825 NORTH BROADWAY WHITE PLAINS, NY 10603 (TOWN OF NORTH CASTLE)

AUTOMOBILE SERVICE STATION ALTERATION (GAS TANKS REPAIR AND CONVENIENCE STORE INTERIOR ALTERATIONS)

We have revised the plans to answer the May 20, 2022 comments from the Town Consulting Engineering John Kellard, P.E. as follows (**in bold**):

DRAWING TITLE:
STORMWATER
MANAGEMENT
PLAN

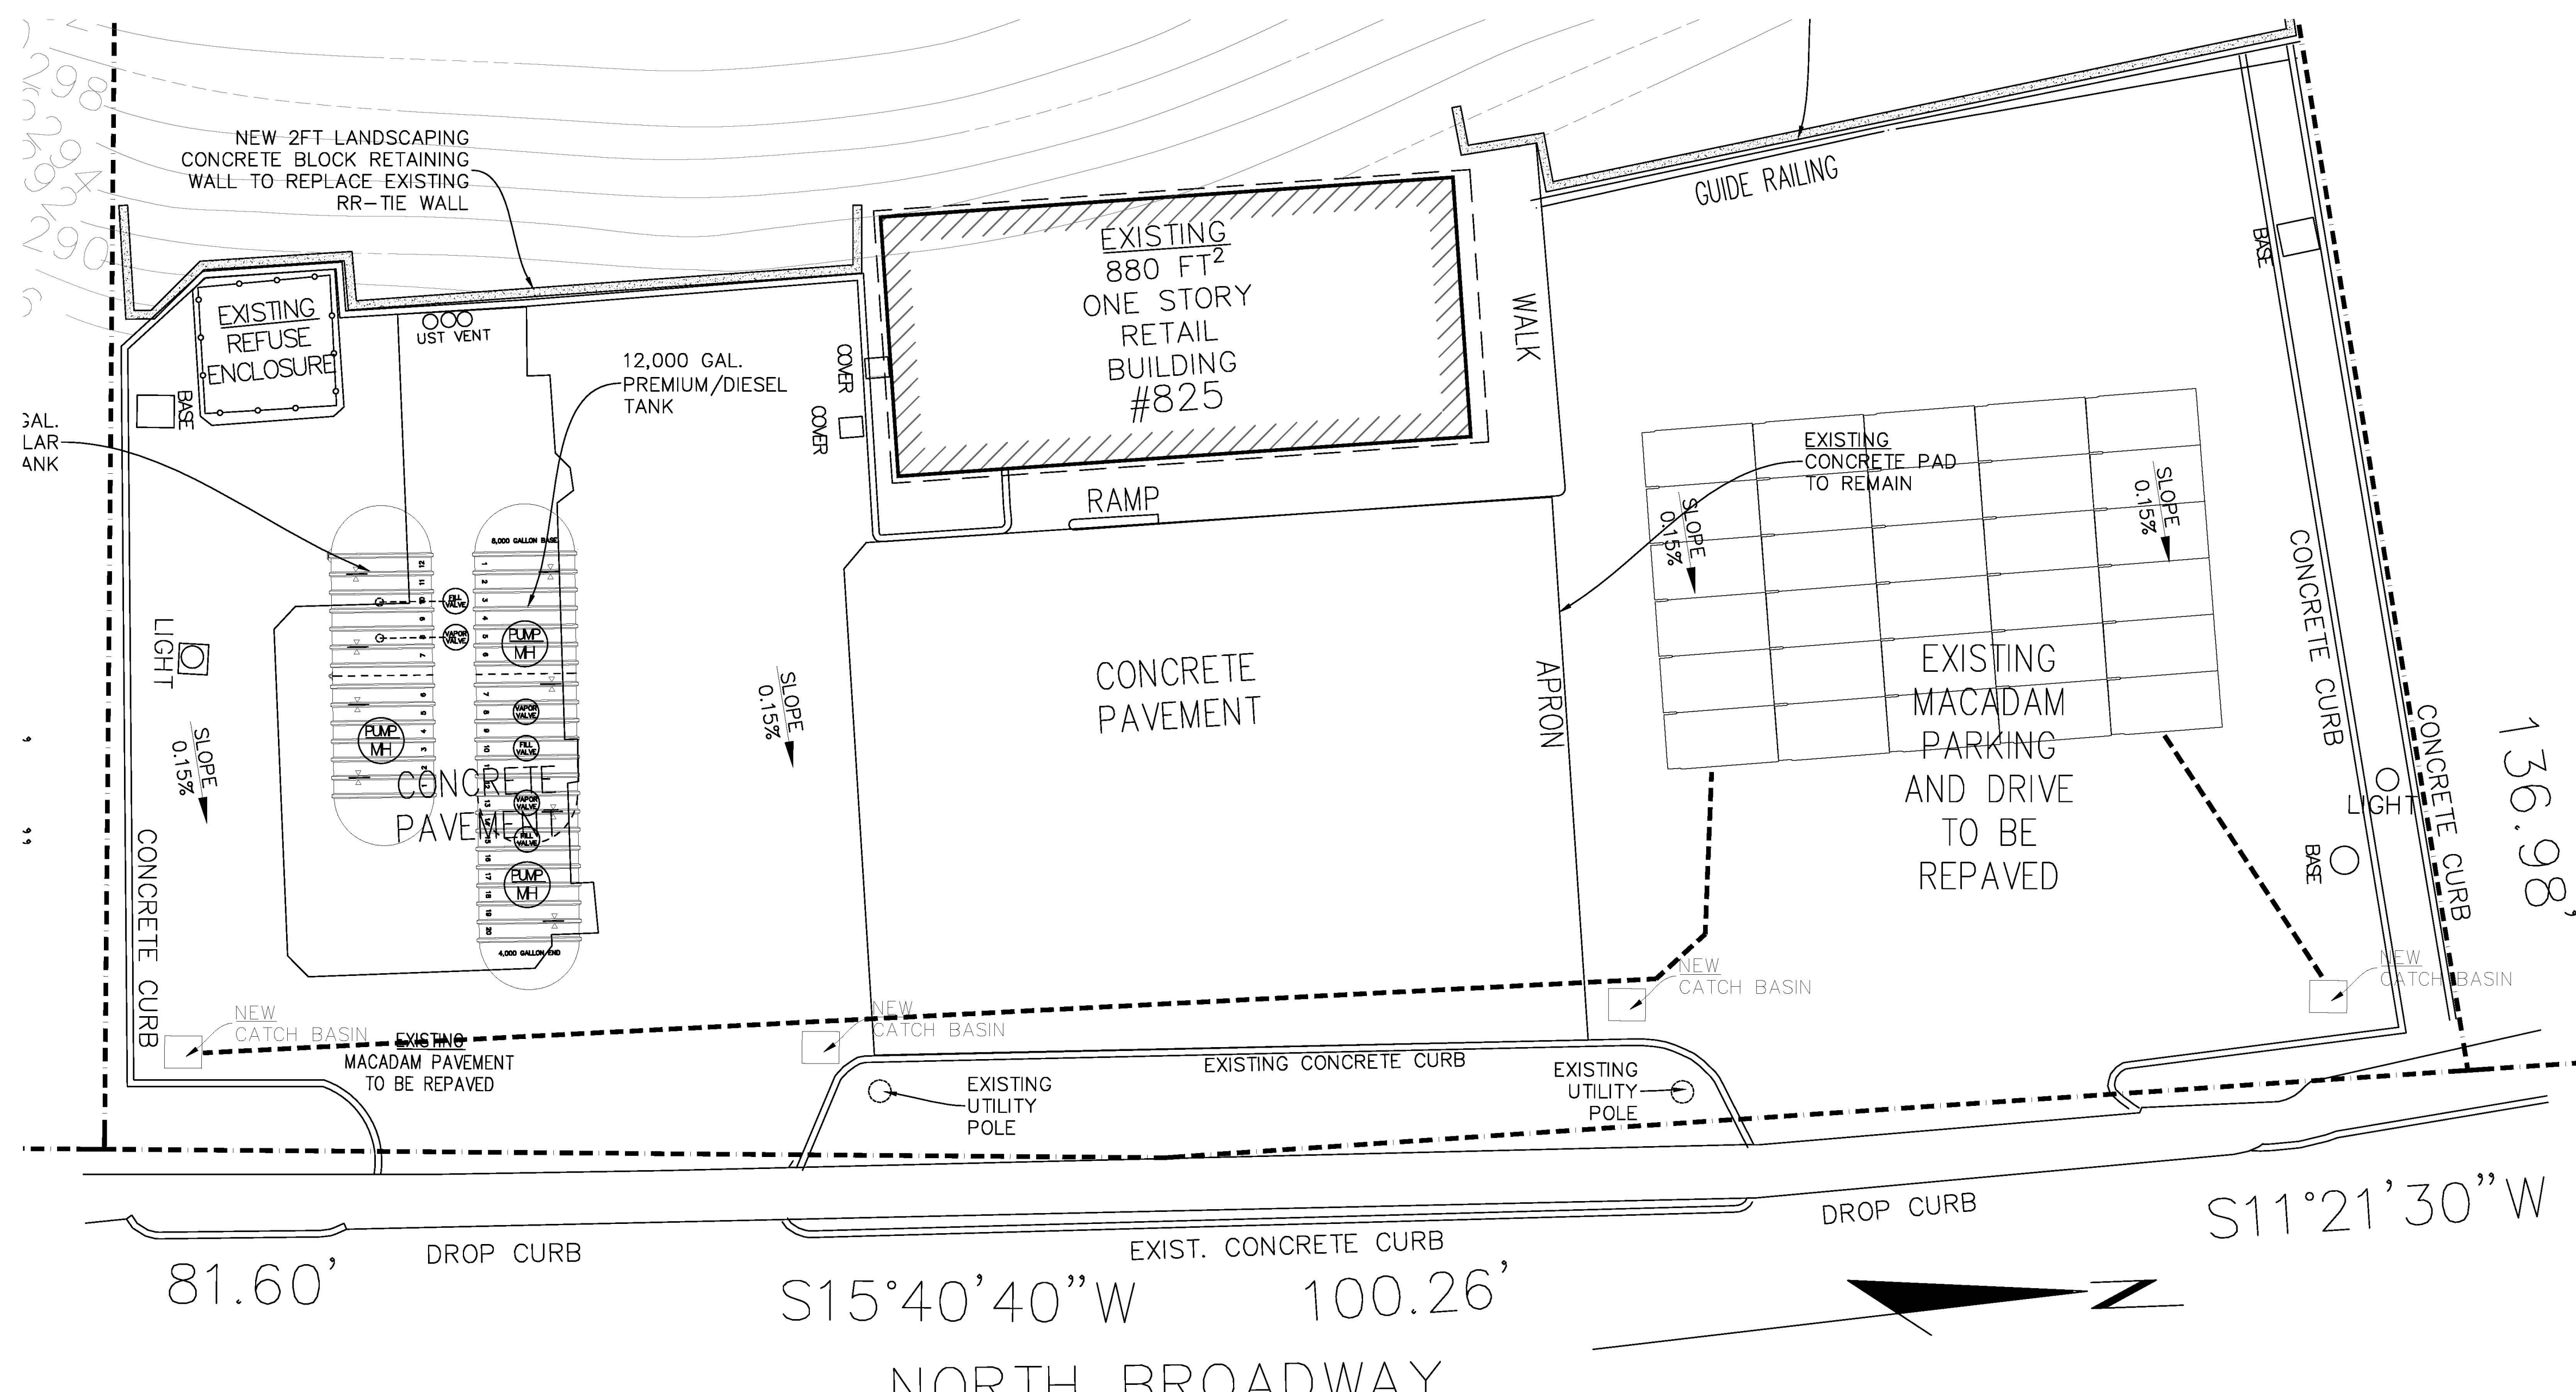
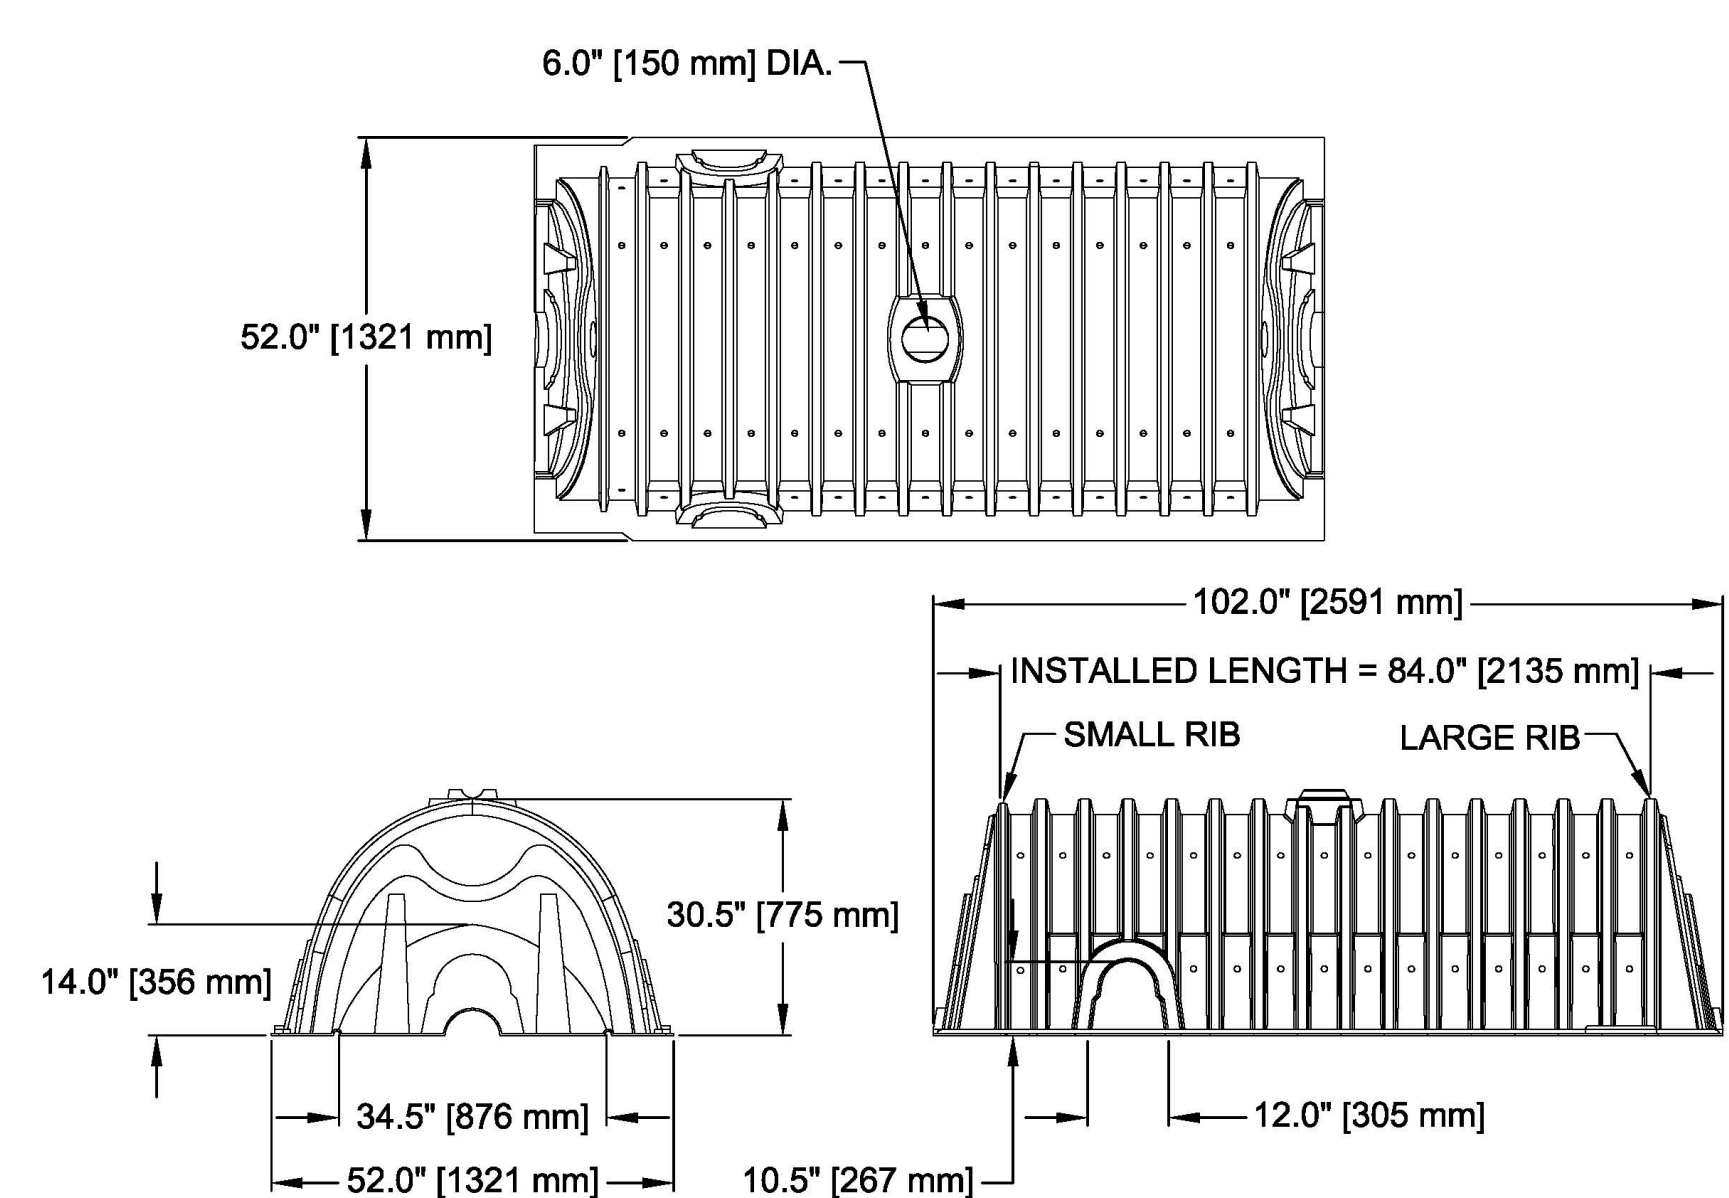
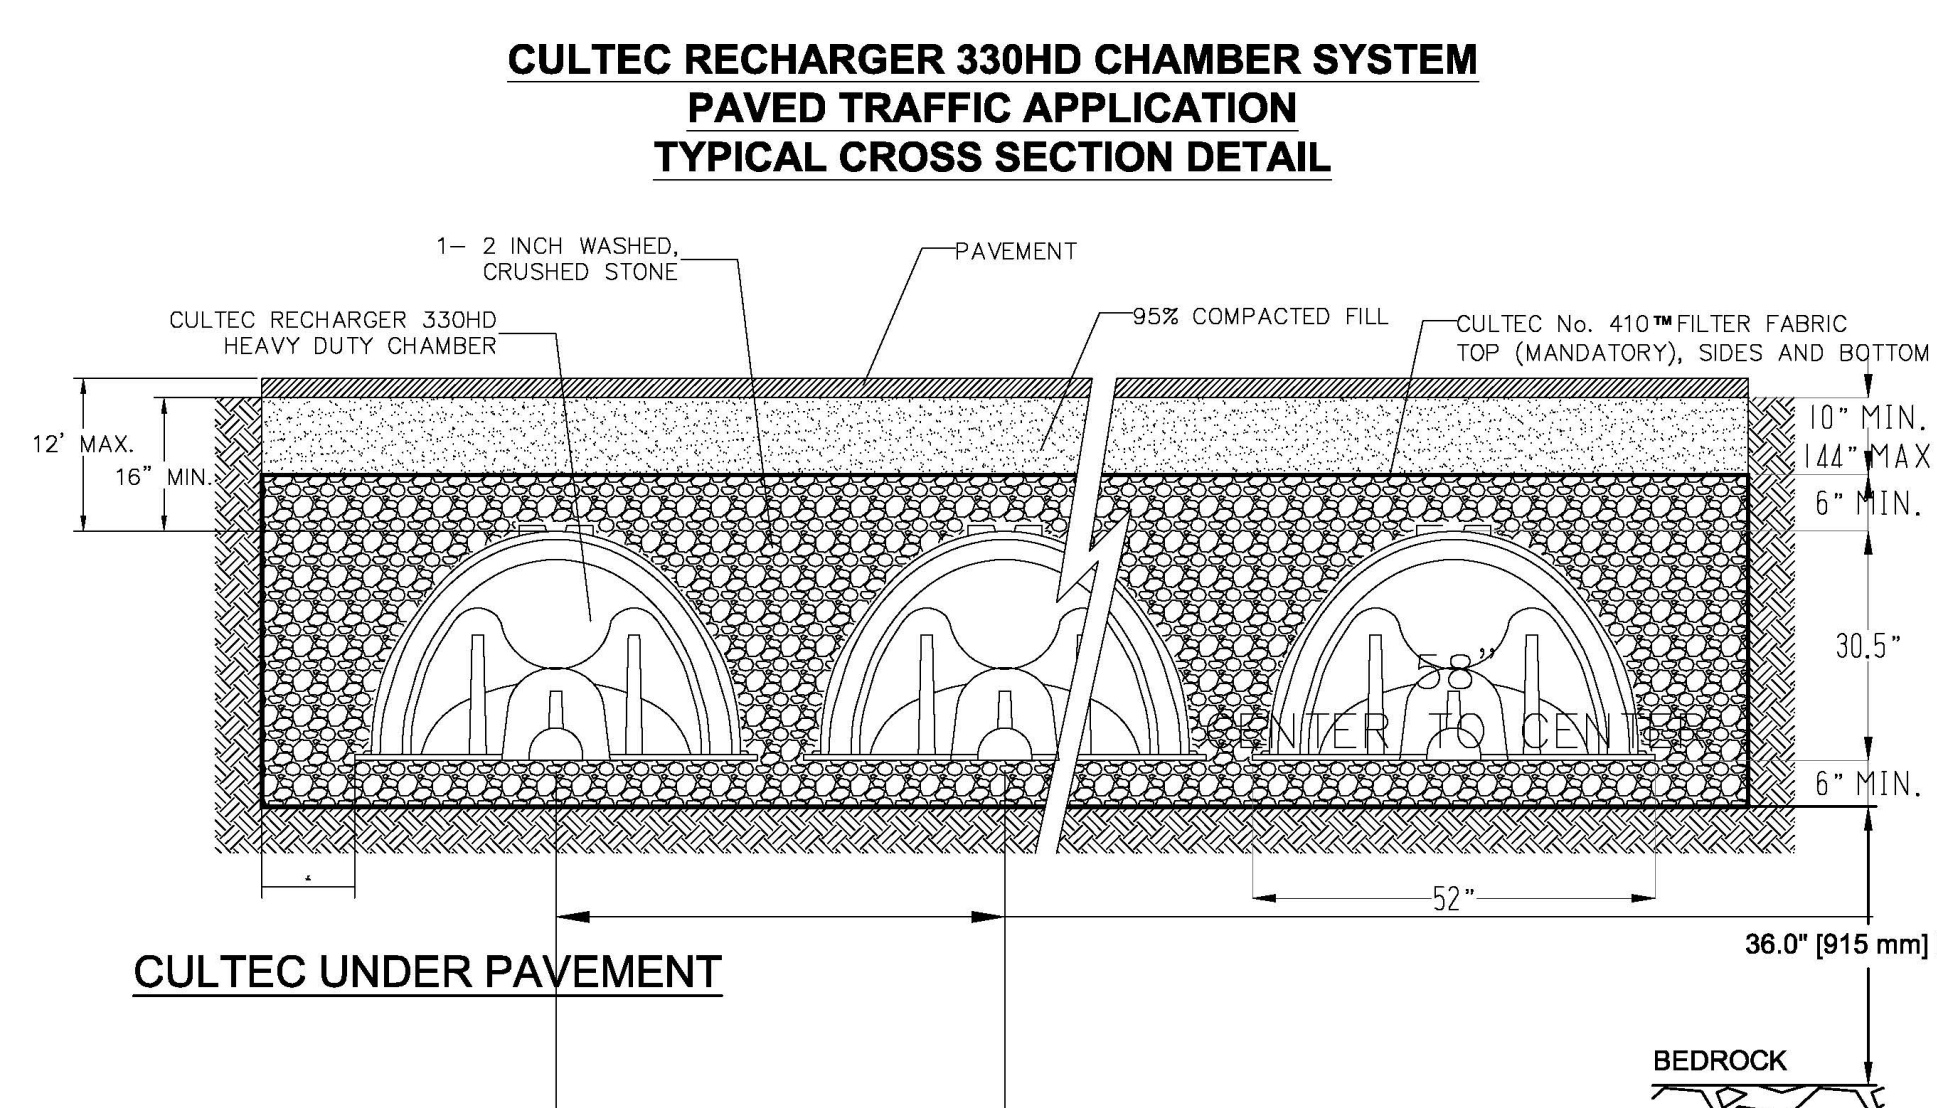
8. The applicant should clarify whether the drain within the northern parking lot is connected to an existing storm drainage system or is a drywell. Please determine its condition.

9. It appears the proposed work will disturb in excess of 6,000 s.f. of the site. The improvements will not increase impervious surfaces and therefore is not required to provide stormwater quantity mitigation. However, the proposed work provides an opportunity to introduce stormwater quality improvements to mitigate stormwater discharge from the project site. The applicant should introduce water quality measures in accordance with Chapter 9 Redevelopment Projects, as outlined in the New York State Stormwater Management Design Manual.

We contacted the State to determine if the existing drainage system on site is connected to any existing storm drain system that may exist in North Broadway. The State was not able to confirm this connection and a site visit concluded that the site does not connect to the street. There is an existing system within the property and we will replace it with a new dry

well system as shown on C3. An oil separator can be added in-line with the drainage system if requested.

New stormwater management page added. Estimated number of drywells required to handle the entire run-off from a 6" rainstorm event provided based soil type. See C3.
